April 2, 2025

Subject: David M. Sunshine & Carol B. Jordan, Two-Lot Subdivision, 1582 Jericho Road, Richmond, VT – Rural Road Plan – Turn-Around Area Location for Selectboard Approval

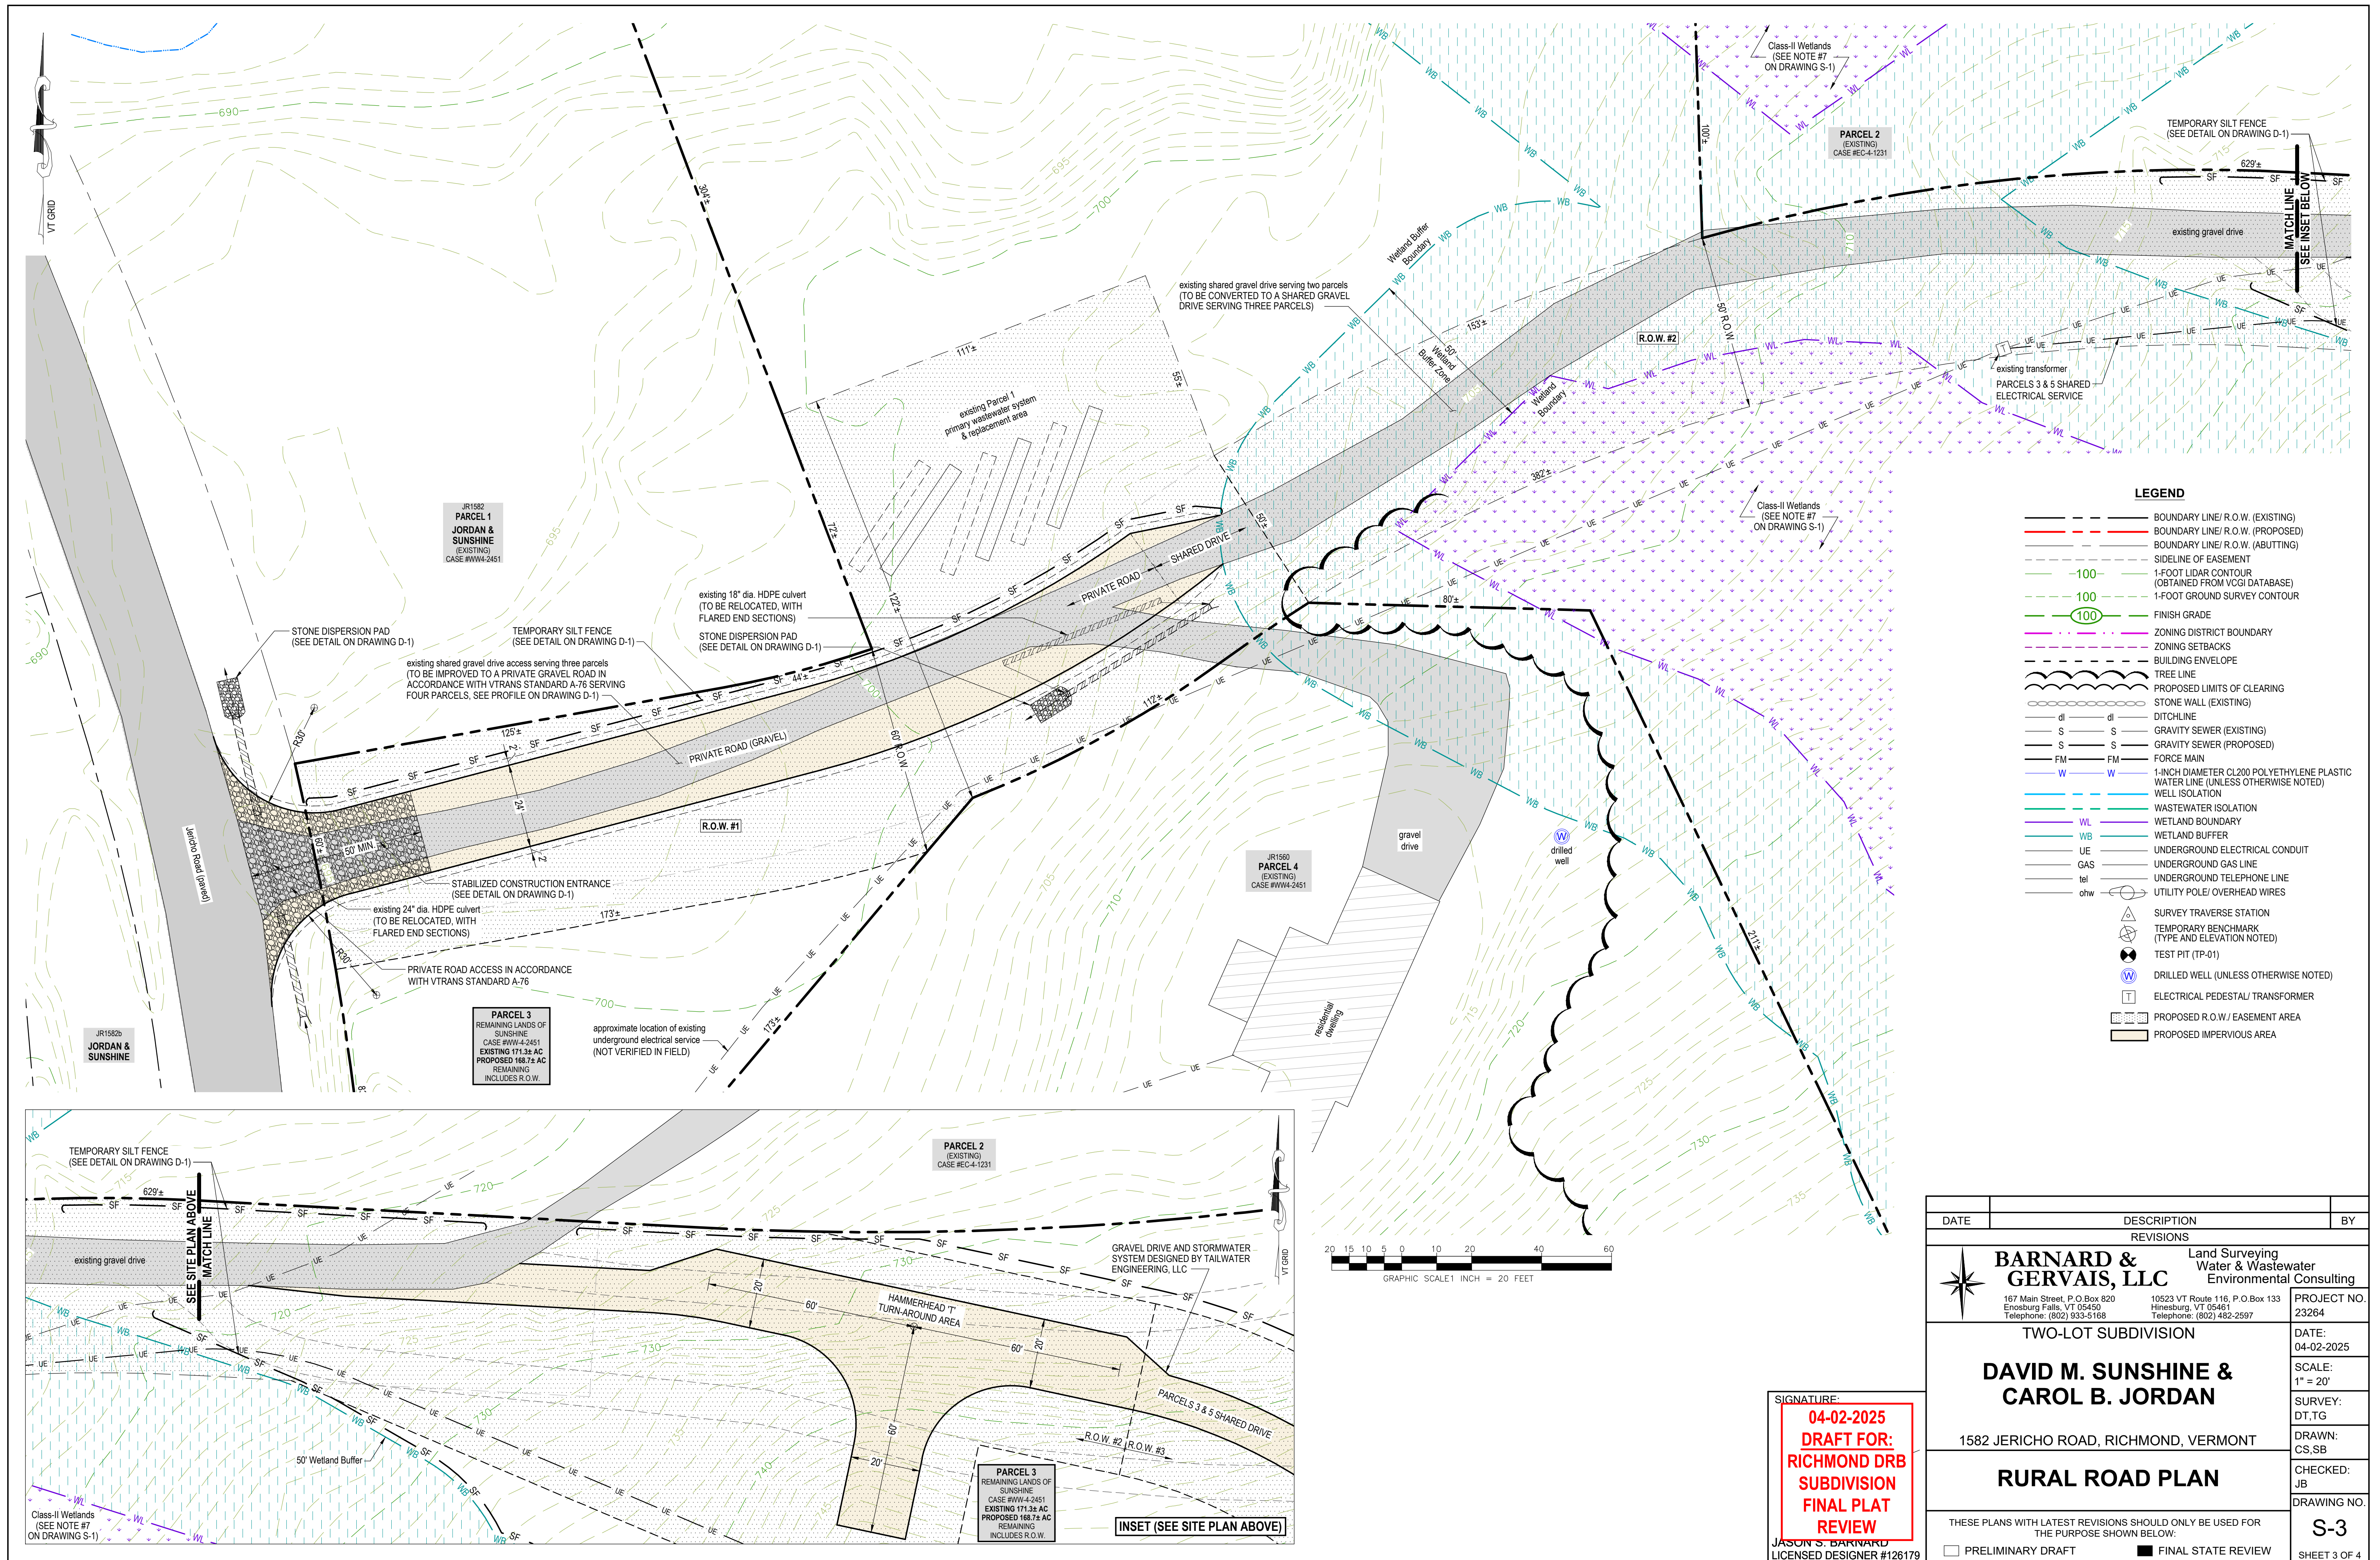
I am writing on behalf of David M. Sunshine & Carol B. Jordan to formally request Selectboard approval of the adjusted emergency vehicle turn-around area location. As per our discussions, the project's stormwater engineering resulted in the turn-around area moving approximately 60' toward the east to accommodate the proposed constructed gravel wetland at the lowest elevation. This minor adjustment is a typical progression from Preliminary to Final subdivision review (for perspective - on this 171.3± acre parcel, the hammerhead location shifted by less than two firetruck lengths).
